**City of Richmond**  
Urban Development Division

## Report to Development Permit Panel

**To:** Development Permit Panel  
**From:** Joe Erceg  
Manager, Development Applications  
**Date:** July 22, 2002  
**File:** DP 01-198041  
**Re:** **Application by Perkins & Company Architecture and Urban Design Inc. for a  
Development Permit at 4388 Bayview Street**

SITE PLAN

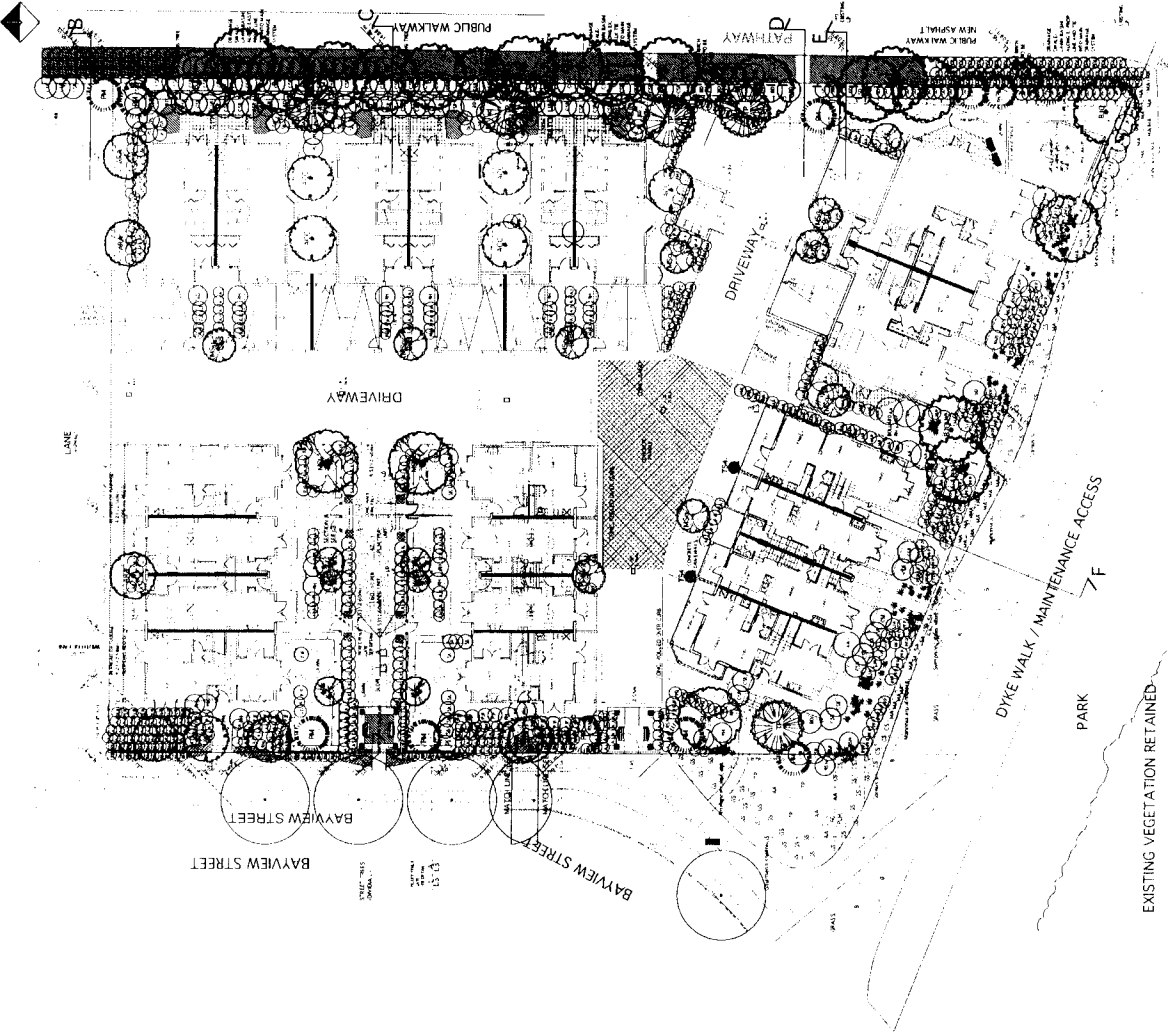
The applicant has revised the landscape plan to selectively increase the planting size of proposed trees and shrubs along the east property line in order to improve the landscape screening and buffering between Parcel 'I' and Westwater Village at strategic locations such as at laneways, driveways and patios. The applicant proposes to match the existing grades along the west property line of the north-south pathway that connects Westwater Drive with Moncton Street. All of the elevation change between Parcel 'I' and the

The applicant has increased the size of proposed plant material along the east property line. In addition, the applicant proposes to supplement the landscape along the west side of the north-south pathway with additional planting where the existing landscape is thin.

EAST ELEVATION - East Property Line Walkway

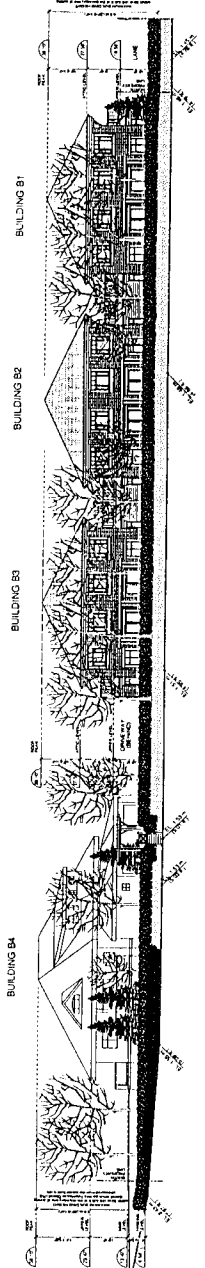
The revised building façade design for the proposed townhouses along the east property line are more in character with the proposed townhouses on the west side of this site including the incorporation of a similar roof pitch and dormer projections.

The revised building orientation along the east property line results in rear yard patios along the east property line creating better visibility and informal surveillance for the north-south walkway along the east property line. With the expectation of eliminating the eastern end of the pedestrian 'mews' that connected with the north-south walkway, the landscape design remains comparable with the previously proposed design. The planting size of strategically located plant material along the east property line has been increased and the applicant also proposes to supplement the existing planting along the west side of the north-south pathway.
